- 1.1. The following information is submitted in response to the Rule 8 and 9 letter (TR010065) dated 15th October 2024 for the A46 Newark Bypass submitted by National Highways for an Order Granting Development Consent. Our comments follow the Council's Local Impact Report (REP1-035), Written Representations (REP2-051) and response to ExQ1 (REP2-050).

- 1.2. The comments made for Deadline 3 are made by Newark and Sherwood District Council in their statutory role as the Local Planning Authority (LPA) and not as landowner.

- 1.3. Having reviewed the information submitted for Deadline 2 (12th November 2024), the Council (as LPA) would wish to comment on submission titled 7.36 Supporting Historic Environment and Visual Impact Assessment (REP2-020). The LPA acknowledges the receipt of information by National Highways at Deadline 2 but does not wish to comment on any matter other than those in this response stated below, which relate to the cumulative effects and the visual impact.

Viewpoint 25 – southwards along Great North Road

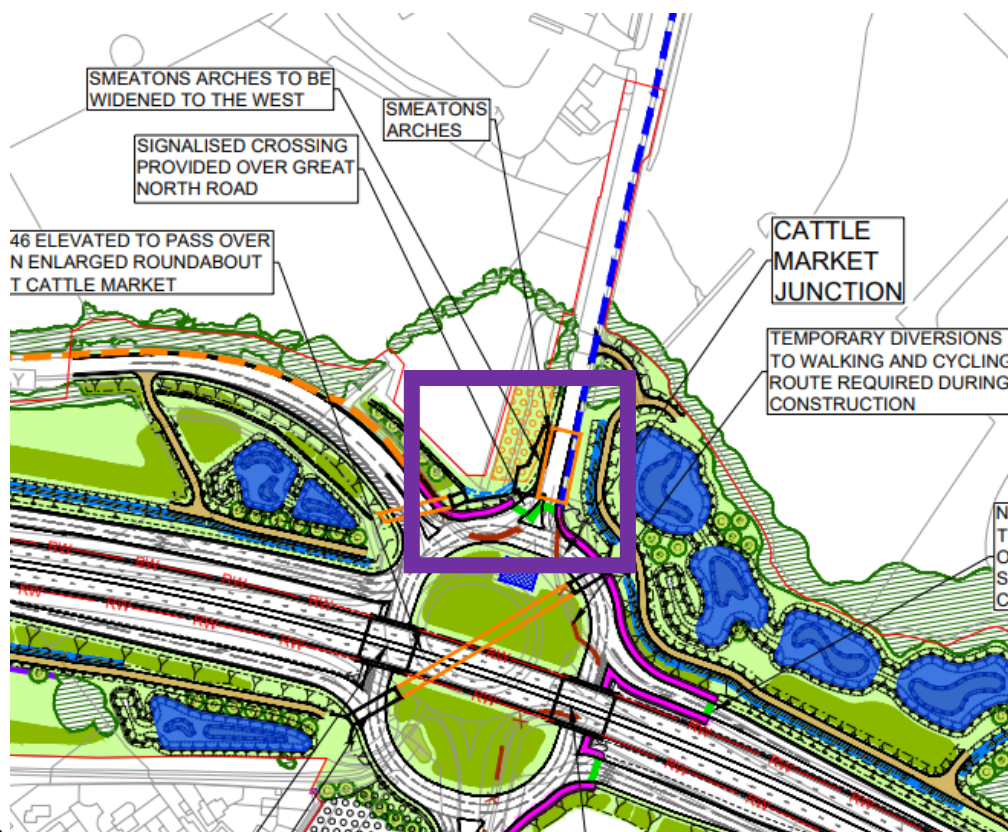
3.9. Due to the alignment of Great North Road, views of the flyover would be experienced from the River Trent and the foot of Newark Castle. This is a heavily used pedestrian route as well as vehicular route, in to and around Newark due to its connections to Newark Castle train station, Riverside Park and obviously the Newark Castle and other heritage assets. The ES Figure 2.3 Environmental Masterplan sheet 3 (AS-026) and the viewpoint at year 15, show that the view of the flyover will be screened with planting, however this is considered to have minimal effect.

3.10. It is not clear if other design approaches have been considered and why this design has been deemed the most suitable for this location, given its sensitivity. It may be that it has been more engineering led as opposed to location, and that screening through landscaping had been considered sufficient mitigation by the applicant.

3.11. Many of our concerns could be addressed through a change in design approach, such as having a more open design by removing the central section (see below). This would allow views along Great North Road, creating a structure that is less of a harsh physical barrier.
